SERVICE BULLETIN

ENGINE — LP COMPRESSOR — INTRODUCTION OF NEW REPAIR ONLY PARTS FOR
FAN CASE ACOUSTIC LININGS WITH NEW ADHESIVE PRIMER

V2500 Series 72-0692

V2500-ENG-72-0692

LOCATION OF ACOUSTIC LININGS
FOR A1 ENGINES PRE V2500-ENG-72-0103
FIGURE 1

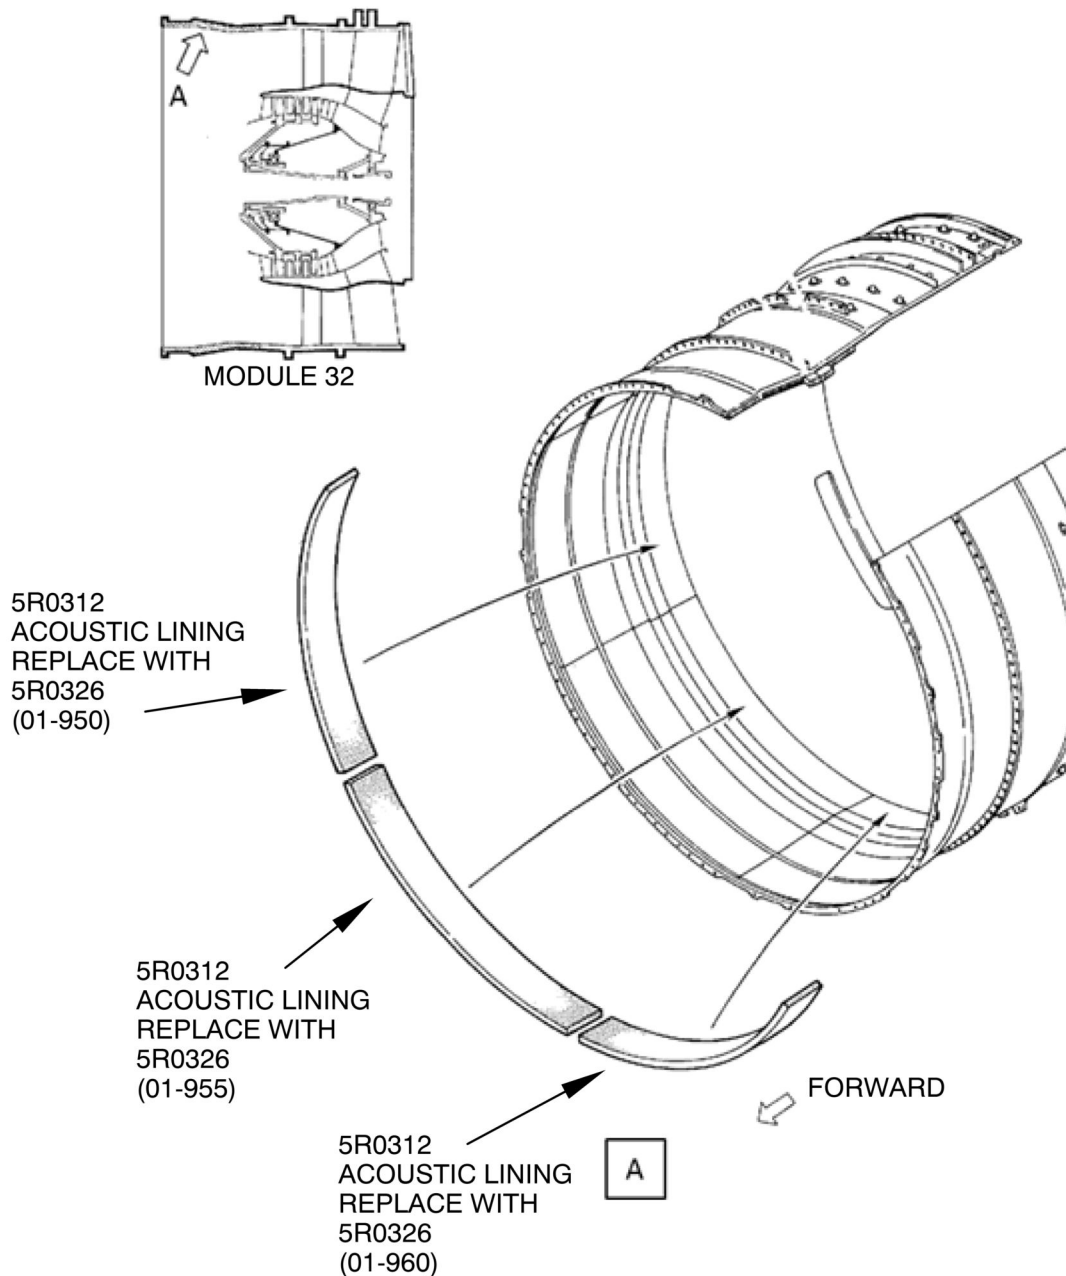
A. Do the repair by replacement of the acoustic linings.

(1) For V2500-A1 Engines Pre Reference 11, V2500-ENG-72-0103:

(a) See Reference 9, Aircraft Maintenance Manual, VRS1575 TASK 72-32-85-300-040.

(a) See Reference 7, Engine Manual, VRS1958 TASK 72-32-85-300-010 (REPAIR-010).

LOCATION OF ACOUSTIC LININGS
FOR A1 ENGINES POST V2500-ENG-72-0103, A5 ENGINES AND D5 ENGINES
FIGURE 2

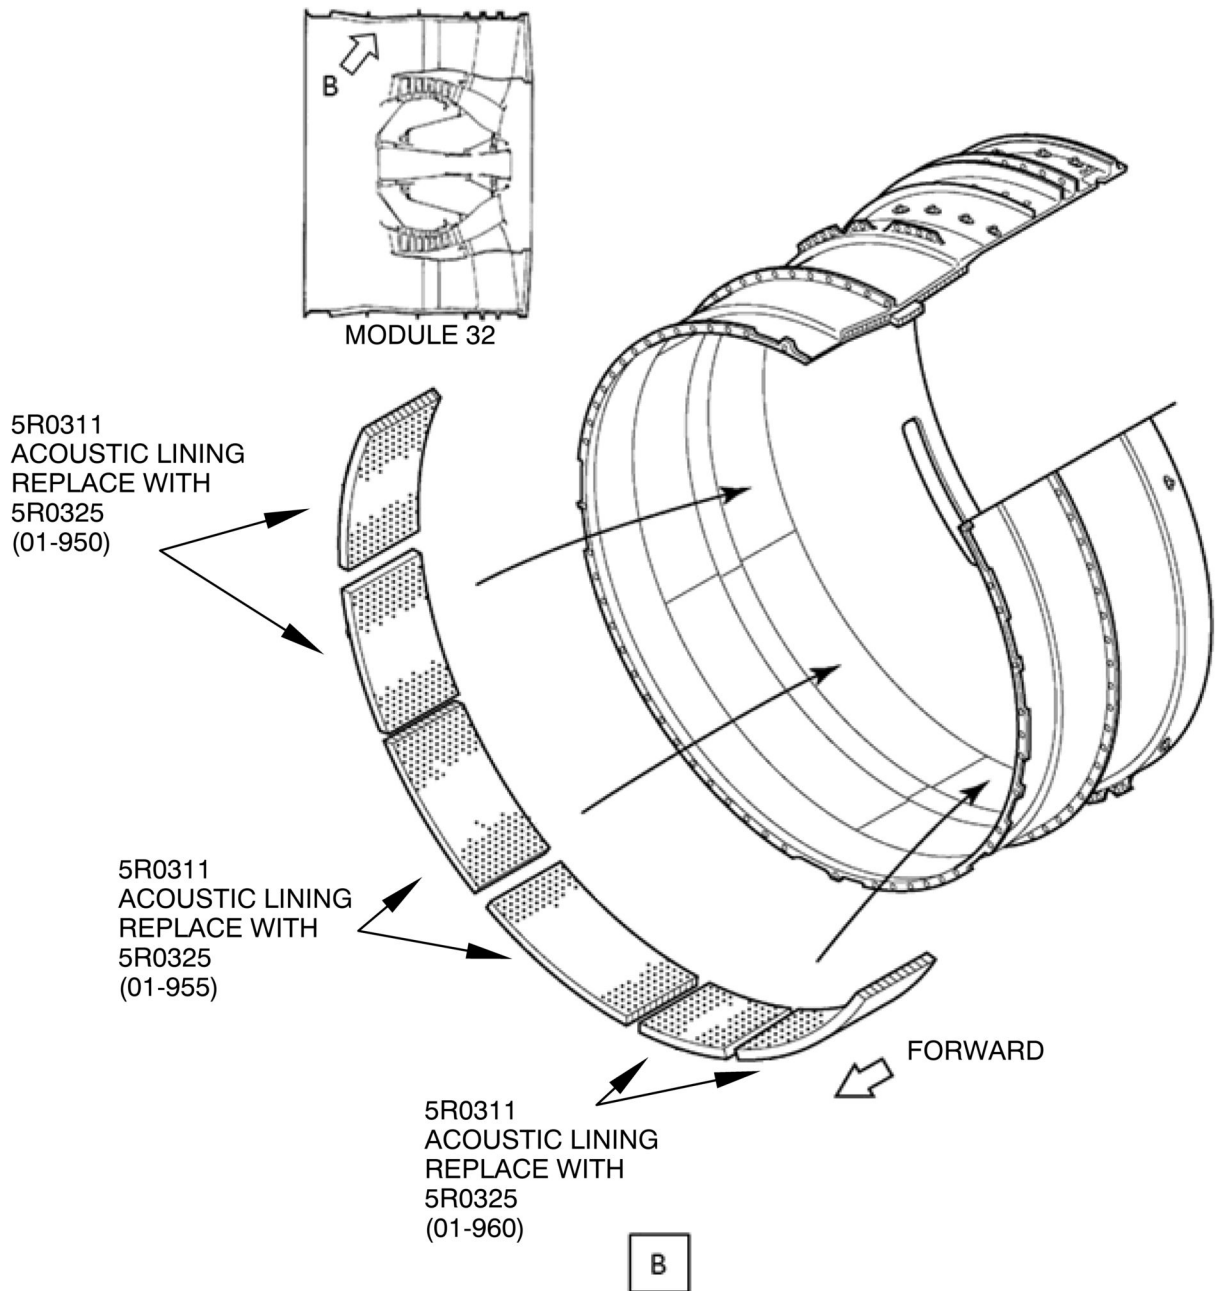
(2) For V2500-A1 Engines Post Reference 11, V2500-ENG-72-0103:

(3) For V2500-A5 Engines:

(4) For V2500-D5 Engines:

(a) See Reference 9, Aircraft Maintenance Manual, VRS1583 TASK 72-32-85-300-018.

(a) See Reference 9, Aircraft Maintenance Manual, VRS1845 TASK 72-32-85-300-020-A.

(a) See Reference 10, Aircraft Maintenance Manual, VRS1853 TASK 72-32-85-300-809.

(a) See Reference 7, Engine Manual, VRS1540 TASK 72-32-85-300-025 (REPAIR-025).

(a) See Reference 7, Engine Manual, VRS1842 TASK 72-32-85-300-041 (REPAIR-041).

(a) See Reference 8, Engine Manual, VRS1849 TASK 72-32-85-300-035 (REPAIR-035).
